CITY PLAN COMMISSION STAFF REPORT

CD-CPC-2026-00028, 00029, 00027

The Hub

Request
Area Plan Amendment
Rezoning
Development Plan (Non-Residential)

sheet
C1.0
Civil
SITE PLAN
permit
25 FEBRUARY 2026

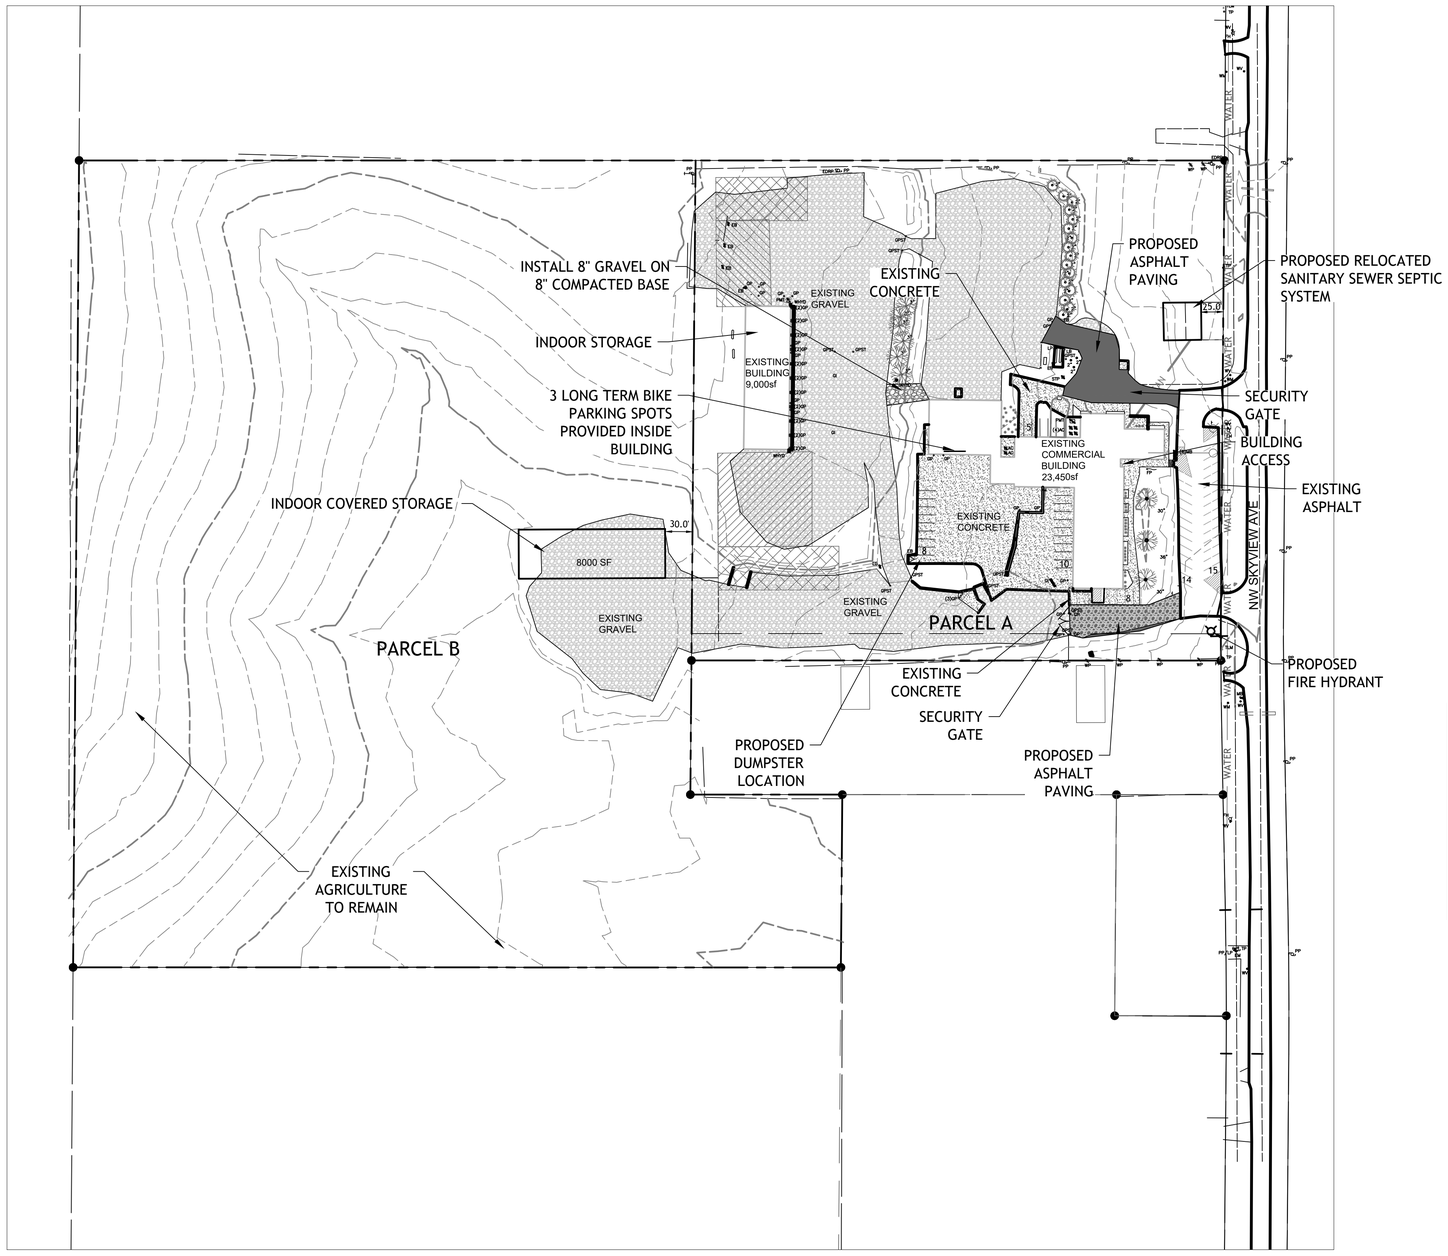
The plan generally complies with the minimum requirements in the Zoning and Development Code. There is a significant amount of gravel currently onsite and indicated on the proposed plan, which the applicant is seeking a variance for if the rezoning to B4 is approved.

The revised plans indicate areas to be paved for accessory outdoor storage of a lesser footprint than the indoor storage areas. There is a condition of approval on this development plan that all outdoor storage must be on a paved surface except the area identified for fire wood and temporary log storage.

There are some sidewalks along the front of the building for people coming from the parking lot along NW Skyview Avenue. There are no other internal pedestrian connections shown on the west side of the school building.

There are no proposed changes to the exterior of the former school building. The existing storage building to the west appears to have received permits for construction as a hay barn, which requires one side to remain open. As the structure exists today, it appears to be fully enclosed, which may be an occupancy issue with the Permits Division, in addition to the permit violation for reuse of the former school building without proper change of occupancy permitting. Staff has added conditions to the development plan requiring proper permitting for all structures on the site.

A second proposed storage building is identified on the western parcel and building plans have been submitted and approved, also identifying it as a hay barn, requiring one side to be open; however, no permits have been issued for this building yet.

The majority of vehicular use area on the site currently contains gravel. Gravel is permitted in the AG-R district, but not the B4 district; therefore, the applicant is seeking a variance for approximately 152,220 square feet of gravel vehicular use area.

6. The property owner shall abate all permit compliance violations within 6 months of development plan approval.
7. The property owner must obtain approval of a variance from the Board of Zoning Adjustment to allow gravel in a B4 zoning district within 1 month of rezoning approval from City Council.

8. All motor vehicle repair uses shall be conducted in an permitted structure and not outdoors for more than 24 hours at a time.
9. All storage containers must obtain building permits within 6 months of development plan approval or be removed from the site.

10. All vehicle storage areas on the property must be located at least 500 feet from any R and AG-R district.

sheet
C3.0
Civil
LANDSCAPE PLAN
permit
25 FEBRUARY 2026

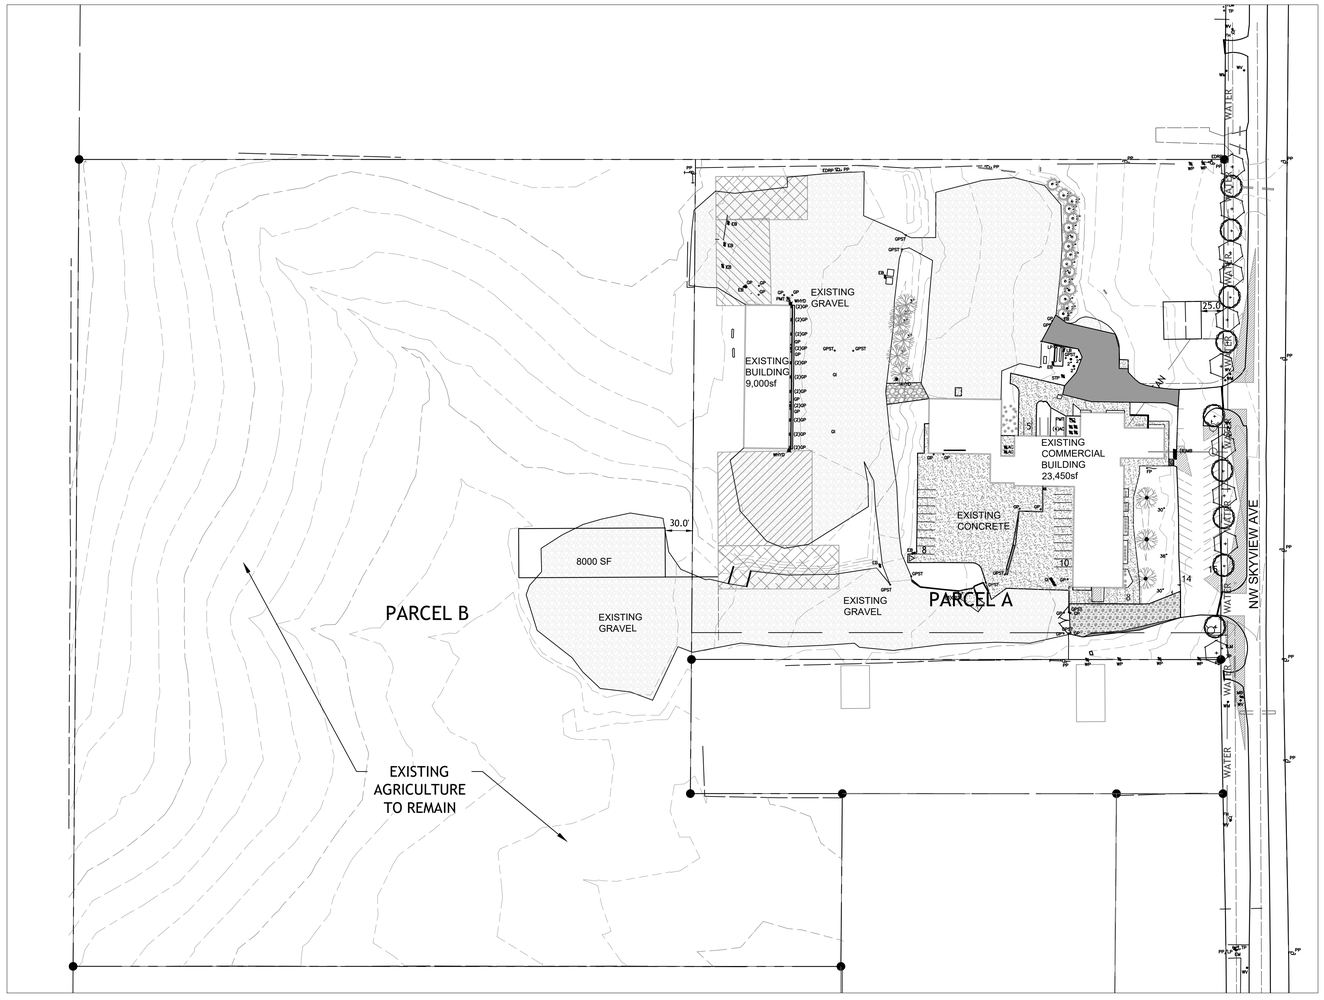
Additional landscape screening will be provided along NW Skyview Avenue to screen vehicular use areas around the site.

No existing trees are identified to be removed.

2. That prior to issuance of the Certificate of Occupancy for each lot within the plat the developer shall submit an affidavit, completed by a landscape architect licensed in the State of Missouri, verifying that street trees have been installed in accordance with the approved Street Tree Planting Plan and are healthy. This condition may be satisfied by an assigned City Planning and Development Building Inspector.
